5DX-62-S

S E R V I C E N O T E

5DX Series I, II, 2L and 3 systems

POSSIBLE X-ray Emission HAZARD

Figure 1: Right side of system

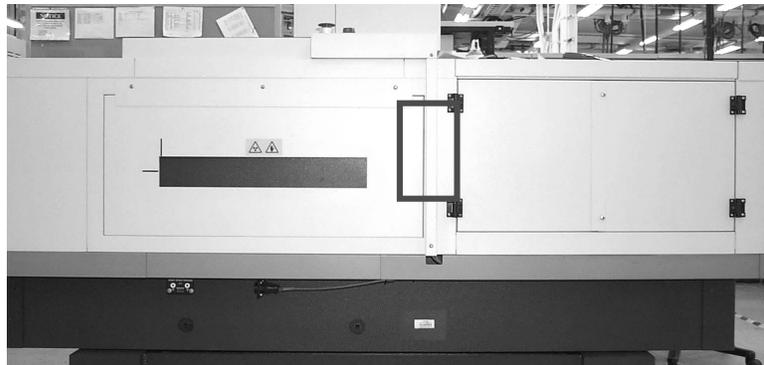
Agilent CE's should inspect this area of each system for damaged or missing rivets when at a customer site. See Figures 1 and 2 below for identification of the affected areas. Most 5DX systems will not have any rivets in this area and hence will not experience this problem. It is expected that this condition affects only a handful of the systems in service.

Inspect the inside of the cabinet in the areas marked in red. Inspect the same areas of the cabinet for Series I and Series II Systems with loaders.

If a damaged or missing rivet is found in this area, perform a local X-ray Safety Test on the area. If the emission levels are above the Agilent specification, the system should be shut down according to the process in the X-ray Safety Test Report.

Order the Rivet Repair Consumables Kit (N7200-60008) and the Rivet Repair Tool Kit (N7200-69011) from GTLS and charge to warranty citing 5DX Service Note 62-S. Repair the rivet according to the provided procedure at an agreed upon time. After the kit is installed, complete a local X-ray Safety Test and document the repair and emission levels on the appropriate report. Charge labor to warranty as well.
